INSPECTION REPORT
Sedimentation Structure
J28-C
Kayenta Mine
Navajo County, Arizona
for
PEABODY COAL COMPANY

Dames & Moore
10139-011-22

SITE PLAN
J28-C

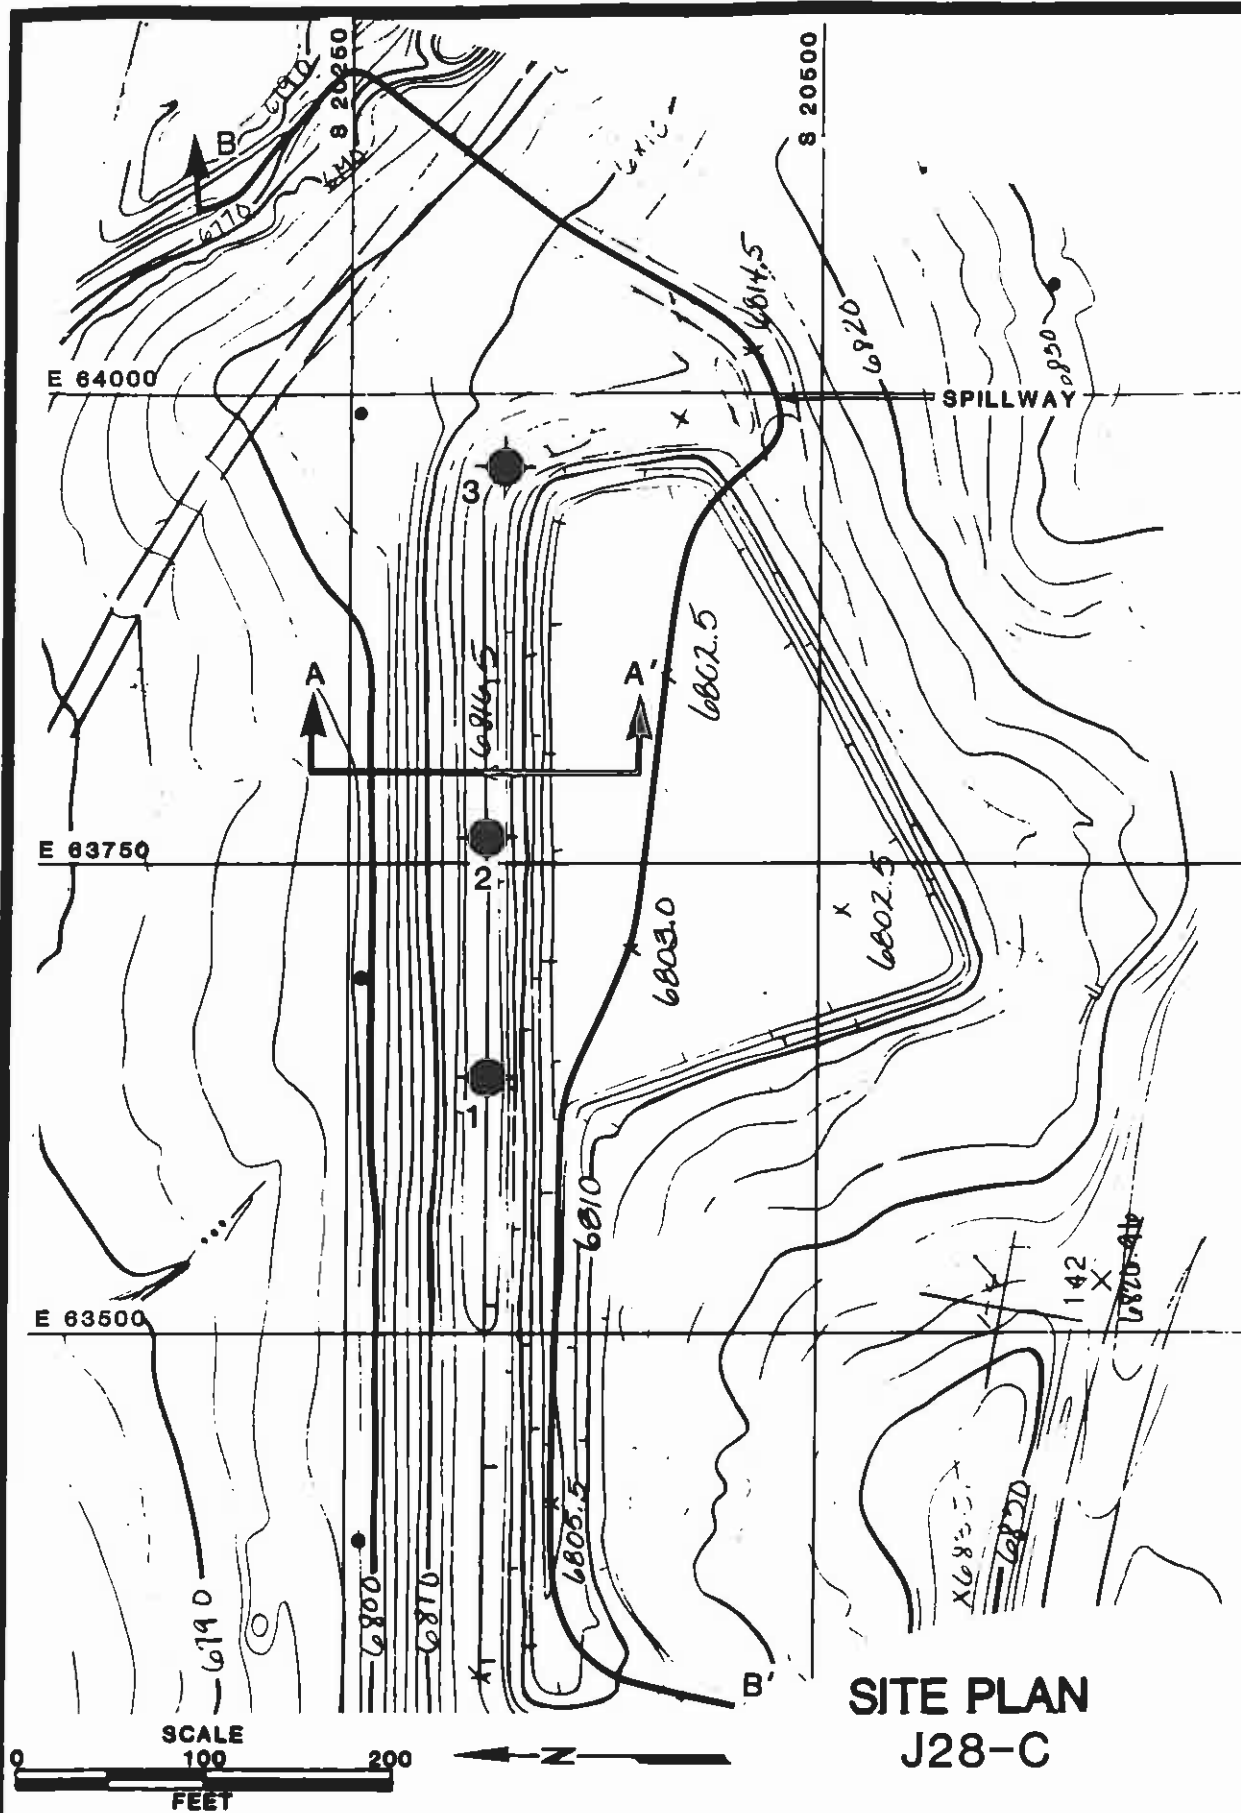
The storage capacity and spillway capacity of Structure J28-C are adequate; however, the spillway does not have an adequate outflow channel or adequate erosion protection. A trapezoidal outflow channel should be constructed along the alignment B-B' shown in Plate 1. The channel profile is shown in Plate 4 and the required dimensions are shown in Plate 5. Both the spillway and outflow channel should be protected against erosion using geotextile and gravel as shown in Plate 5.
